APPEAL RECOMMENDATION REPORT

Central Area Planning Commission

Case No.: DIR-2018-1288-COA-1A
CEQA No.: ENV-2018-1289-CE
Incidental Cases: None
Related Cases: None
Council No.: 4 – Ryu
Plan Area: Wilshire
Neighborhood Council: Greater Wilshire
GPLU: Very Low II Residential
Zone: RE15-1-HPOZ
Legal Description: Lot 130, Arb None, TR 6388

PROJECT LOCATION: 619 S June Street

SHEET TITLE
SECTION B-B
TRANSFORMER PAD
&
DWP STANDARD

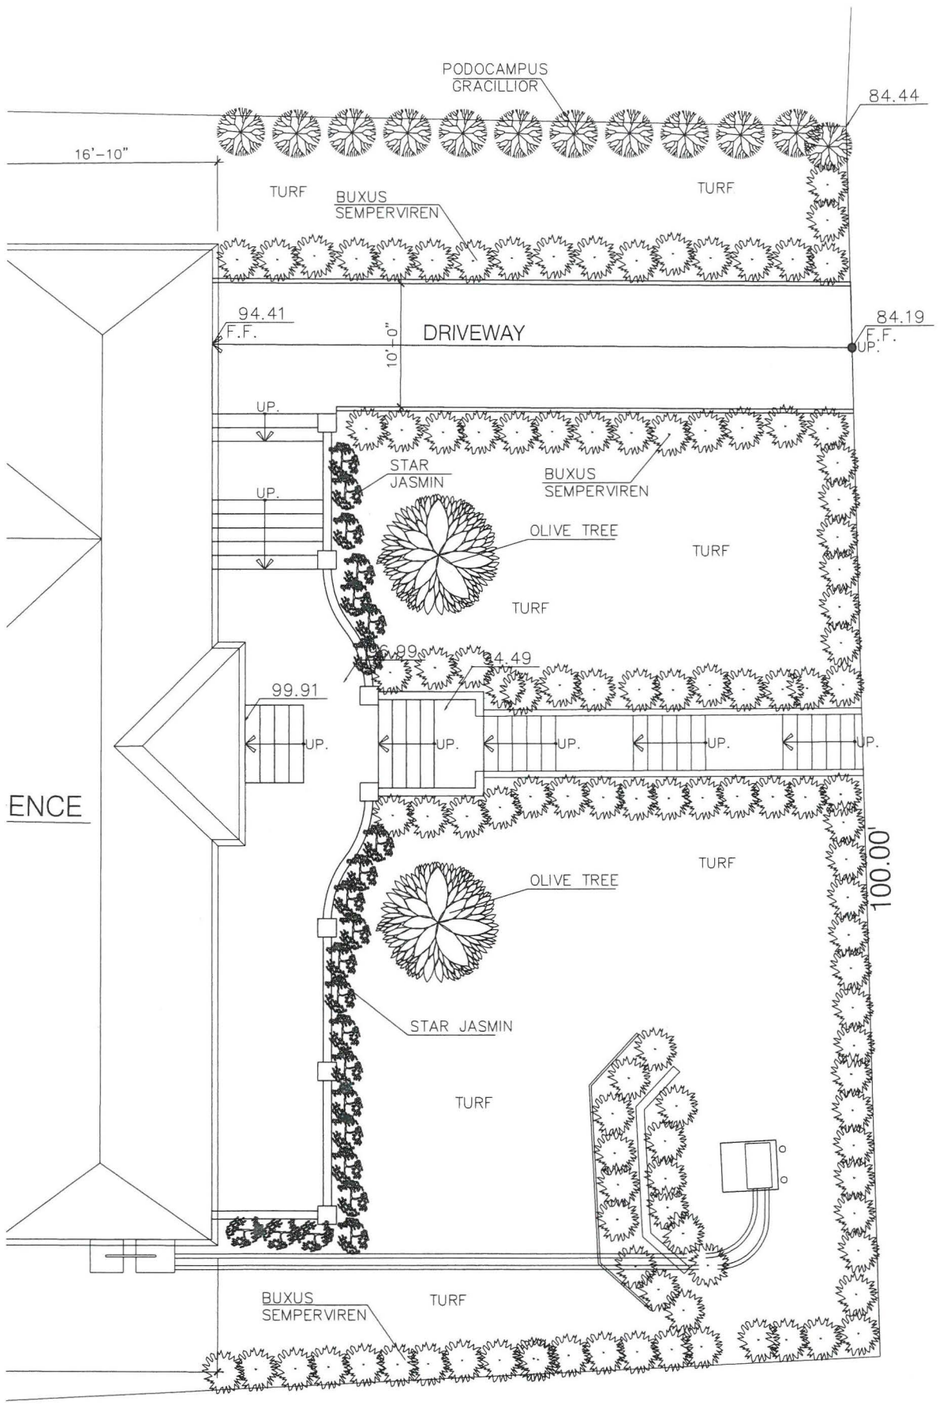
Appeal Point No. 2 – *The Hancock Park Preservation Plan states that no new fencing or walls be constructed in front of an historic property, per Section 8.2 of the plan.*

The Hancock Park Preservation Plan specifically states in Section 8.2.6 that new fences are discouraged except on Rossmore and Highland Avenues of the historic district. The preceding guideline (8.2.5) specifically discusses the potentiality of installing a new retaining wall in the front yard of a property, thus indicating that the construction of a new retaining wall is both possible and, upon review, acceptable.

a. Retaining wall at transformer shall be poured-in-place concrete. No stucco cladding shall be applied.
    b. Organic groundcover be planted in the front yard area.
    c. Curbs on either side of the driveway shall be removed.

4.8kV CUSTOMER SERVICE REQUIREMENTS
619 S JUNE ST
SINGLE FAMILY RESIDENCE

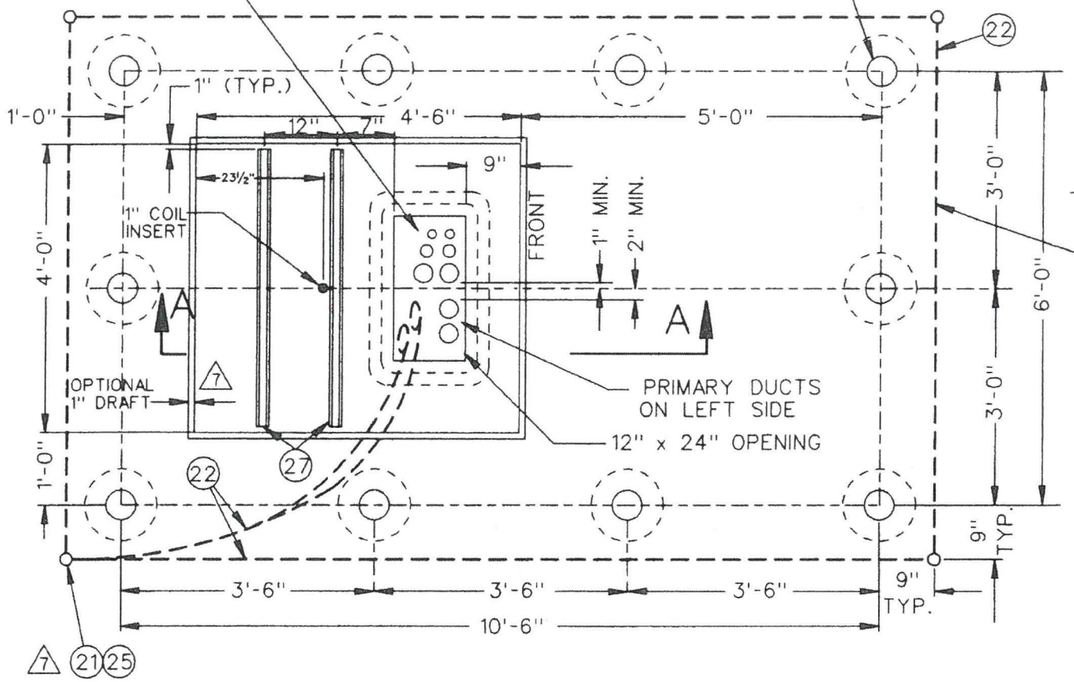
Appeal Point No. 3 – *The Hancock Park Preservation plan states that mechanical equipment be placed in the rear of the property, per Section 8.9 of the plan.*

The appellant refers to guidelines 4, 5, 6, 7, and 8 of Section 8.9 of the Hancock Park Preservation Plan, in which it is stated that: [Mechanical] apparatuses not mounted on a structure should be located in rear or side yards whenever possible; mechanical apparatuses not mounted on a structure may be installed in street-visible areas if there are no technically and economically feasible alternatives; mechanical apparatuses placed in street-visible locations should be obscured from view where possible; utilities should be placed underground where feasible; and mechanical apparatuses (e.g. electrical masts, headers, and fuse boxes) be located at the rear of a structure where possible.

LADWP conducted a feasibility study of the site, regarding the installation of the transformer and appurtenant equipment at the rear of the lot. This study concluded that the cost of an underground installation of the transformer equipment at the rear of the lot would range between $120,000 and $150,000. Due to the exorbitance of this cost, the Director of Planning determined that the enforcement of the guidelines' recommended location would result in an unfair and onerous burden for the property owner, and thus qualifies as being technically and economically infeasible. The guidelines allow for street-visible location of mechanical equipment in the event that no other technically and economically feasible alternative exists. Moreover, the proposed project features a terracing of the mechanical equipment, and the obscuration of the equipment via shrubbery, thereby screening the equipment from the public right-of-way. The Director of Planning has not erred.
